2024/90792 St Peg Lane Highways Note

- 1.1 This note reproduces information submitted to the above application by email on 19 June 2024, in response to Kirklees Council email of 7 June 2024 which provided the comments of Kirklees Council highways development management on the development proposed.
- 1.2 The highways officer's comments were discussed with the applicant's highways consultant (Mosodi) who provided advice to inform the response below.

Drawing Title:
VISIBILITY SPLAYS

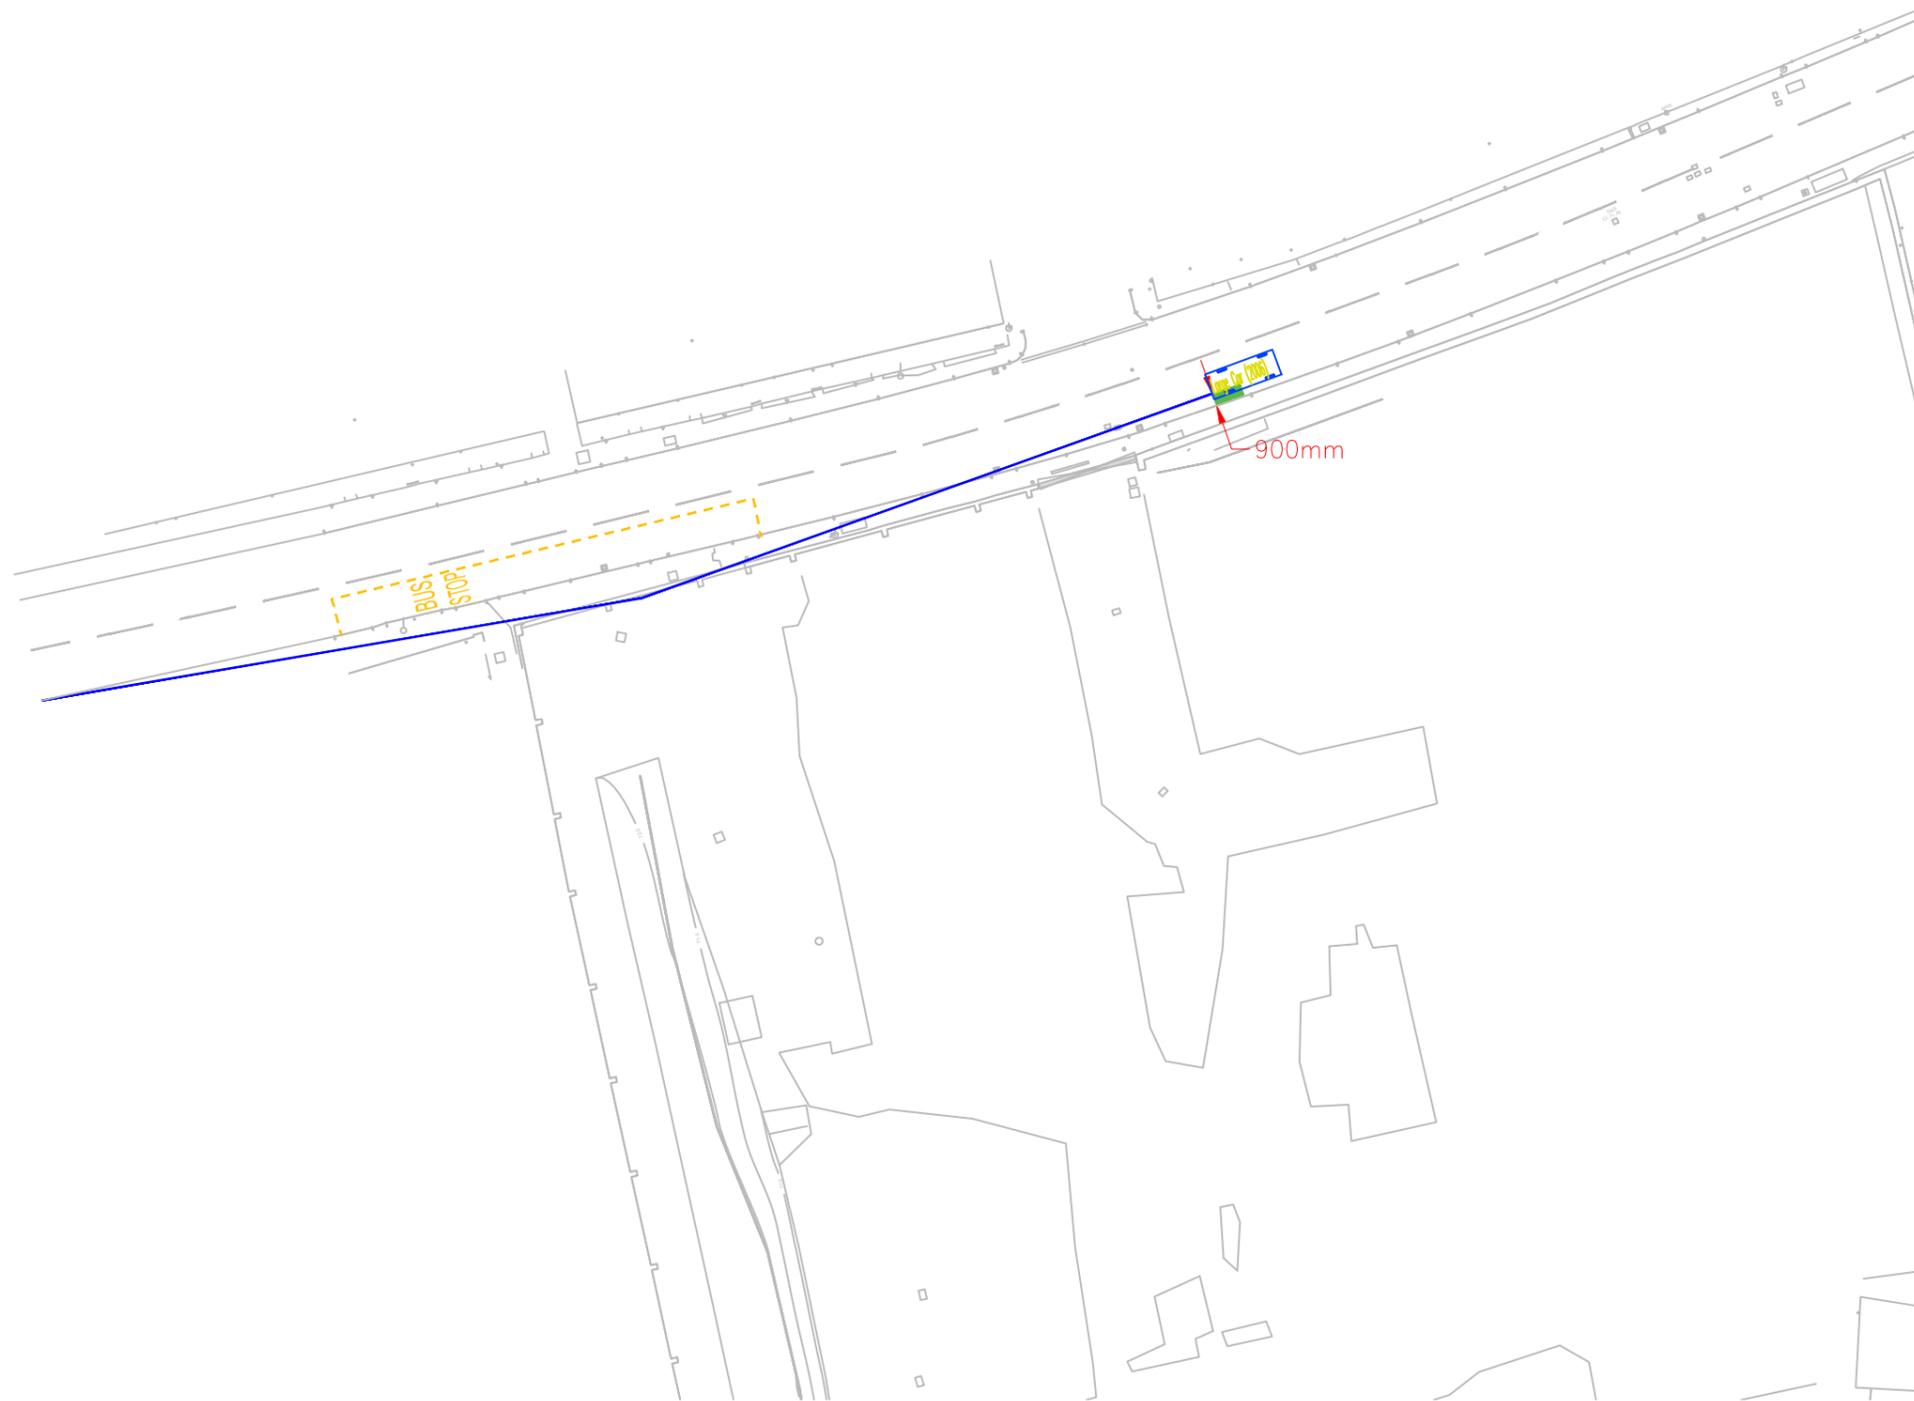
2. *No details of the proposed sight lines from the proposed access onto St Pegs Lane are provided. 2.4 x 4.3 m sight lines need to be shown.*
- 2.4 Please see the attached drawing ref. 23005.SK.01, which shows that visibility splays of 2.4m x 4.3m are achievable with the proposed access arrangement. The 'Y' distance to the right is measured into the carriageway which is appropriate as noted in the Manual for Streets 2 (paragraph 10.5.3). It is appropriate therefore to measure the splay to a 900mm offset from the kerb line as any vehicle approaching the site entrance from this side will be visible at this point including a bicycle (the smallest design vehicle) travelling at a 450mm offset from the kerb line (which is very tight as would just be avoiding gullies in the channel line). This design process is supported by LTN 1/20 (para 7.2.1).

Drawing Title:
 Proposed Site Plan

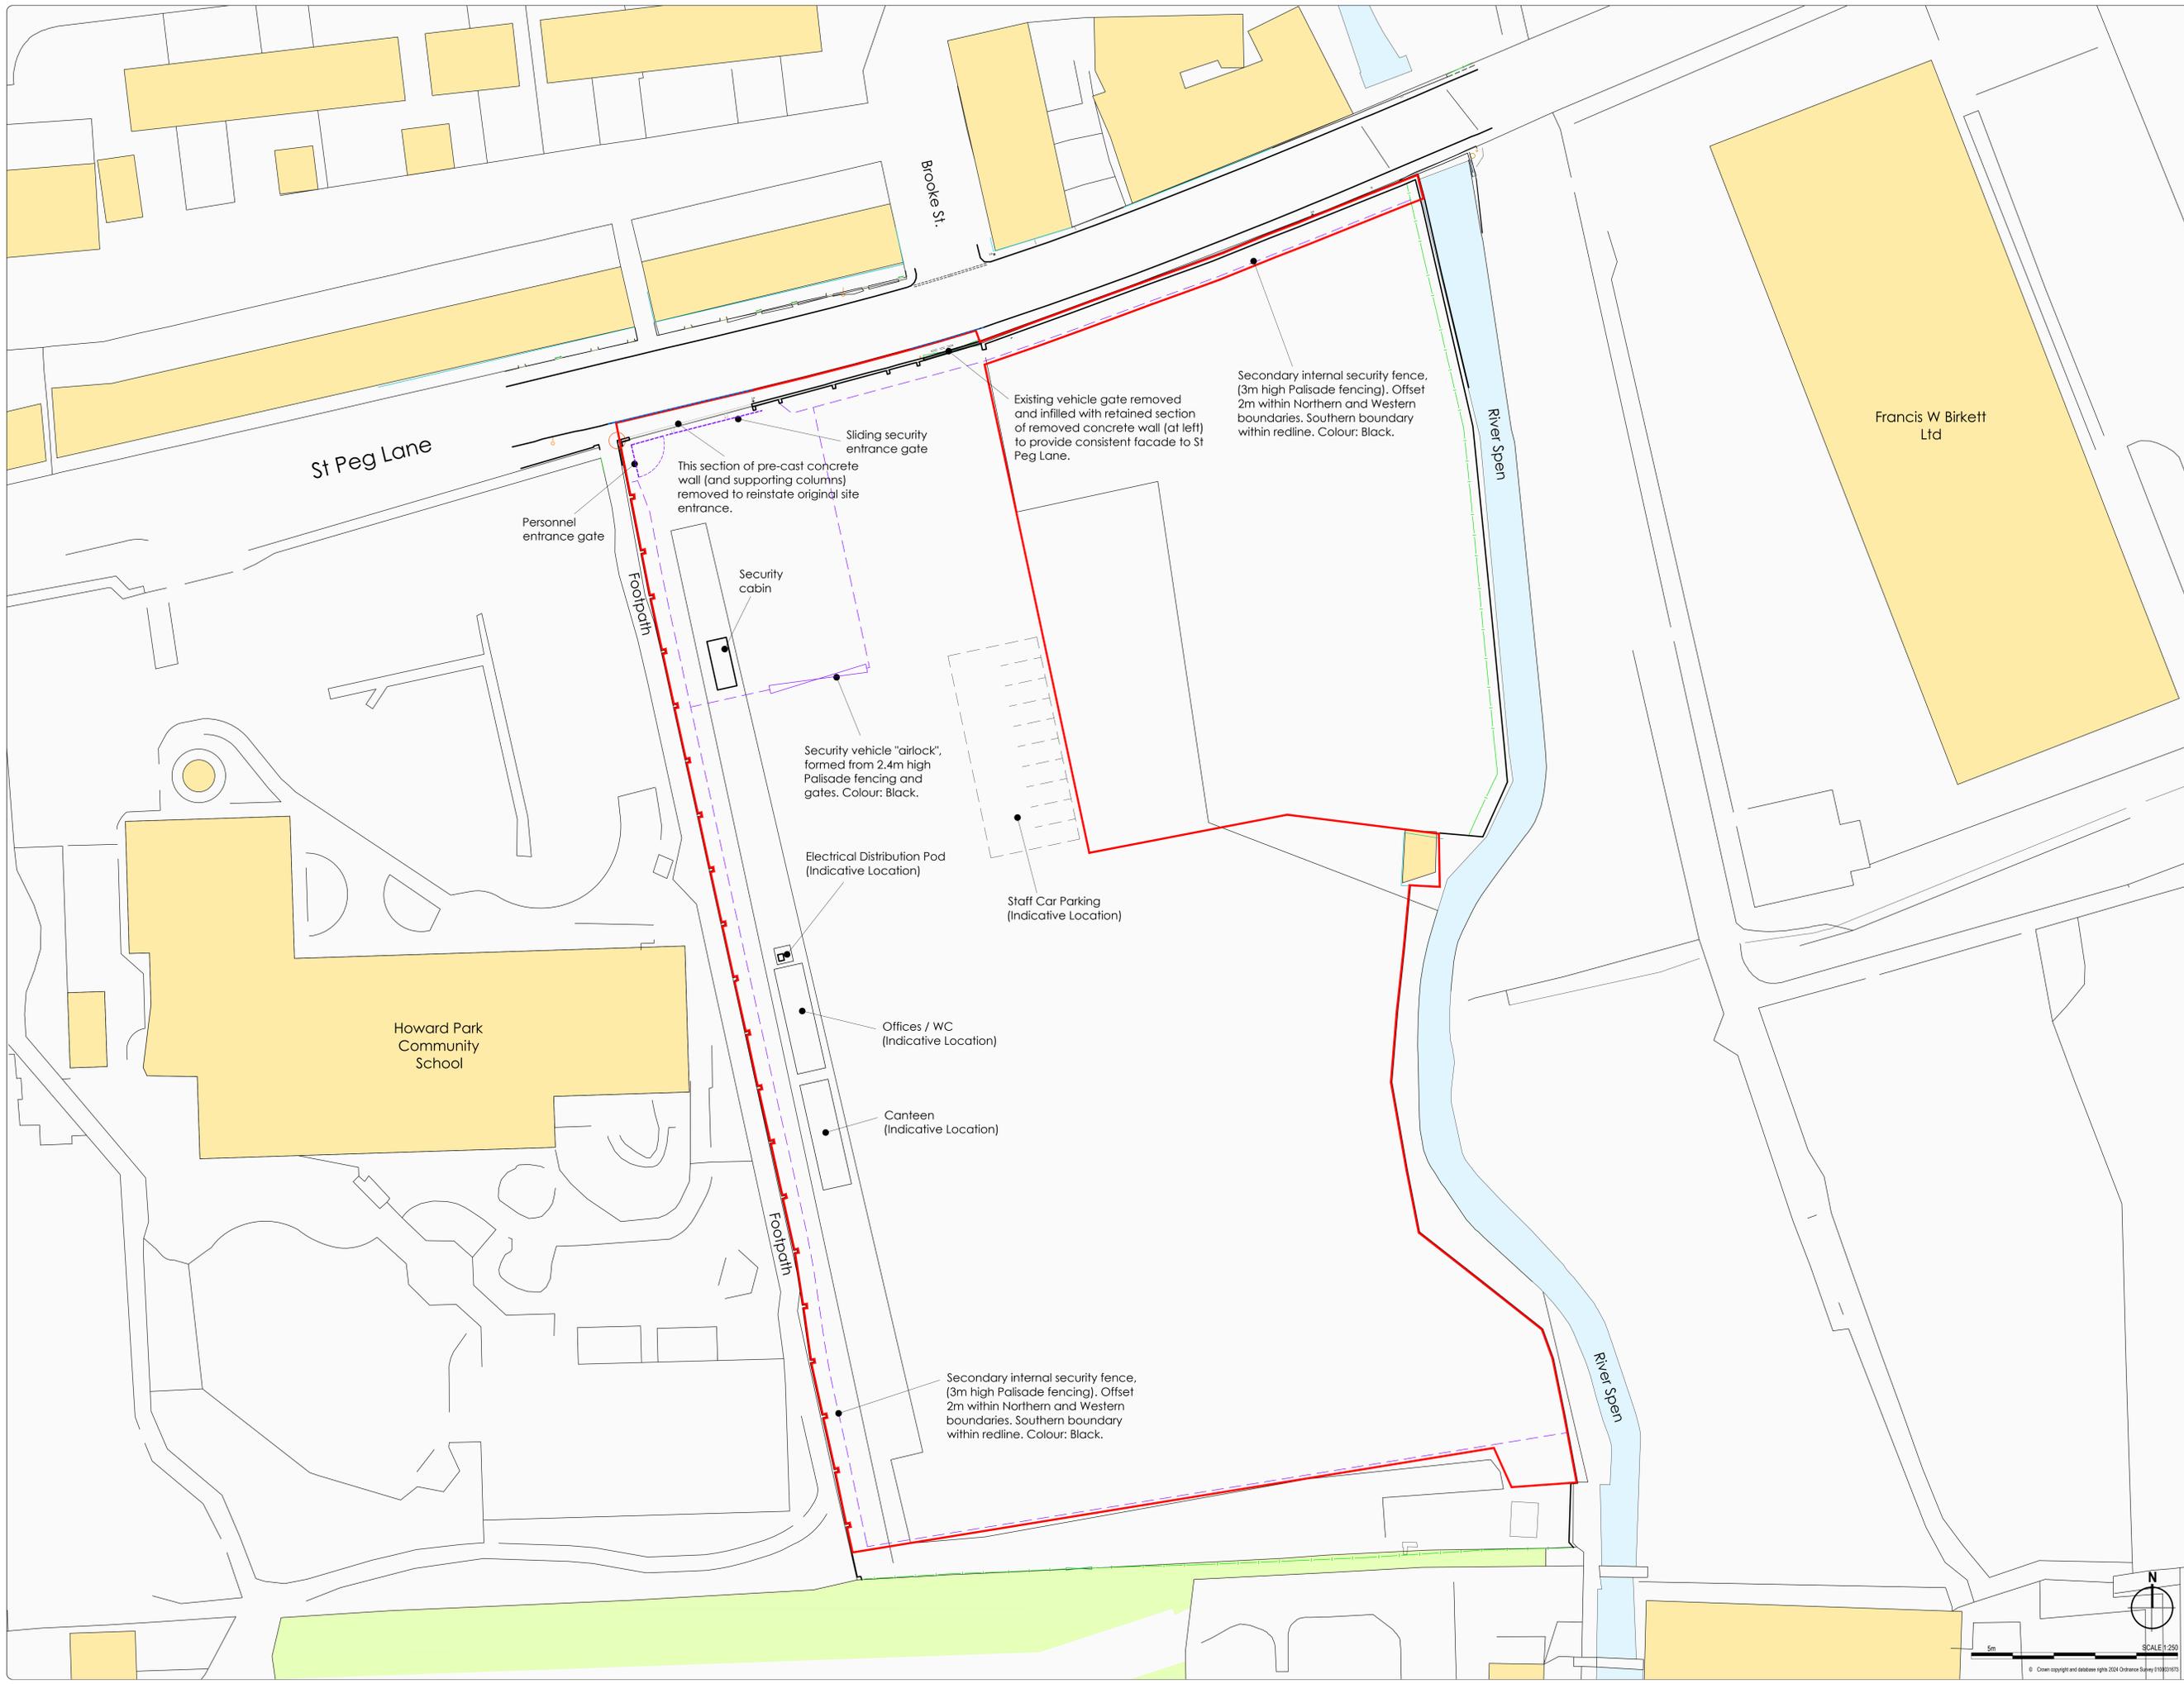
- 6. Details of the proposed staff parking areas should be provided.*
- 2.9 Please see attached drawings ref. 0004_P03 and 0007_P03, which shows the location for staff car parking, nominally showing ten spaces, but not to be marked or limited as such.
